RECEIPT DATE: 6/18/14 **ONSITE SEWAGE DISPOSAL SYSTEM** P 554512-B

PROPERTY ADDRESS: 11270 Independence Way

OPERATION AND MAINTENANCE AGREEMENT FOR AN ON-SITE SEWAGE DISPOSAL SYSTEM HAVING AN ADVANCED PRE-TREATMENT SYSTEM

LOT PLAN FOR BAT INSTALLATION
 LOT 61
HOMWOOD CROSSING
 LIBER 9808, FOLIO 204
 PLAT No. 18244
 TAX No. 05-443245
 FIFTH ELECTION DISTRICT
 HOWARD COUNTY, MARYLAND
 ADDRESS: 11270 INDEPENDENCE WAY
 ELLICOTT CITY, MARYLAND

WALL CHECK
LOT 61
HOMWOOD CROSSING
LIBER 9808, FOLIO 204
PLAT No. 18244
FOURTH ELECTION DISTRICT
HOWARD COUNTY, MARYLAND

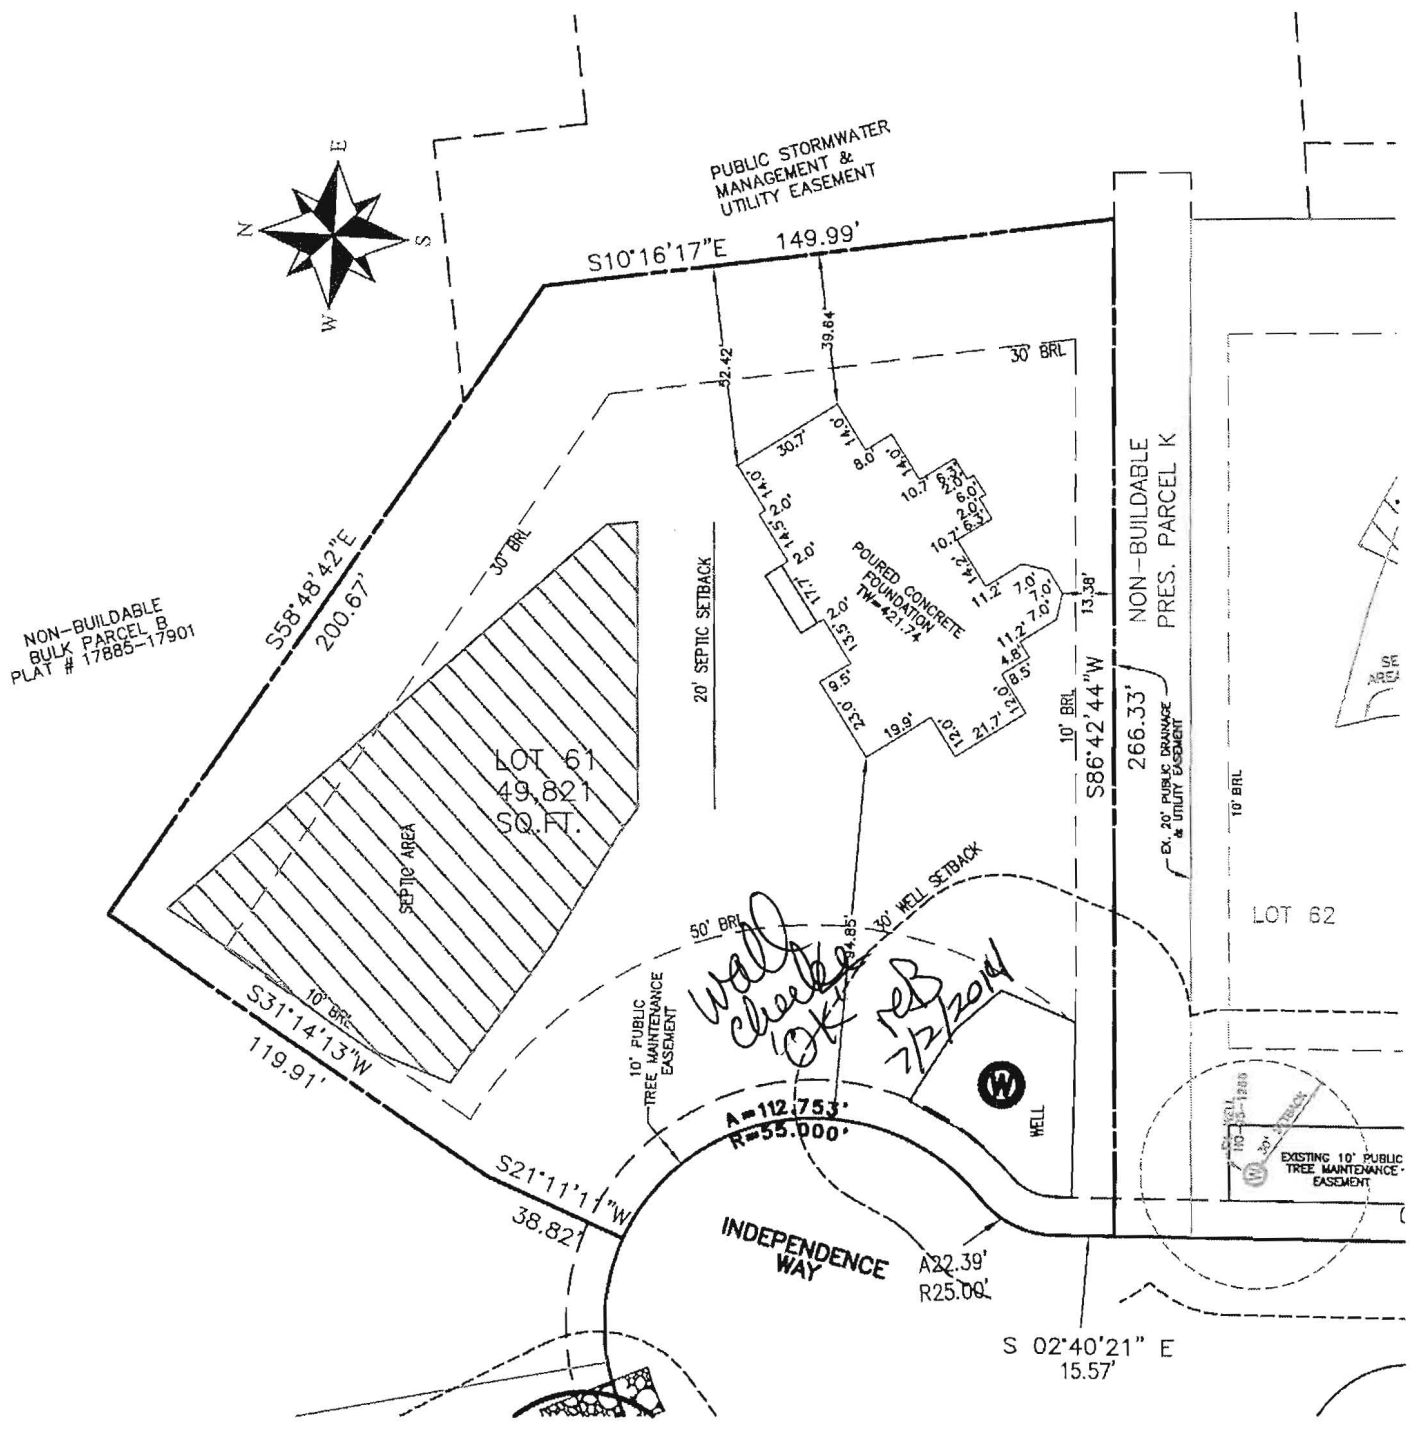
*wall check ok
JW
7/1/14*

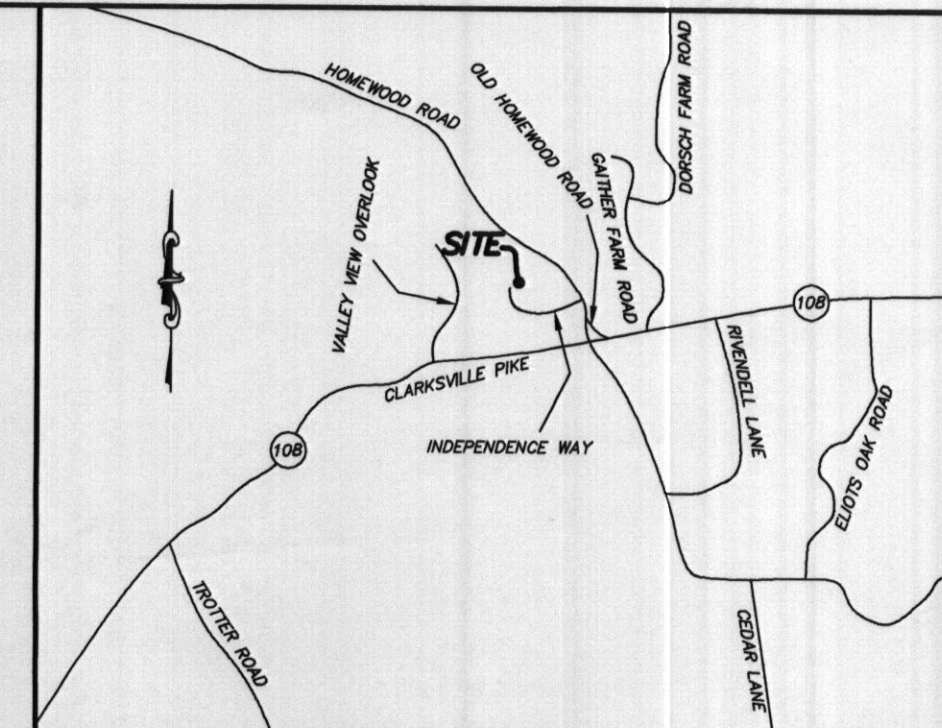
Homewood lot 61 I would like the tank and d-box to be moved up close to the front end of the trenches (the upper middle of the area) if possible. The tank will have to be 100' from the well box, which might put it into the septic area, but there is not a trench in that part anyway so it's ok.

Revised/moved septic tank and distribution box per your comments in email.
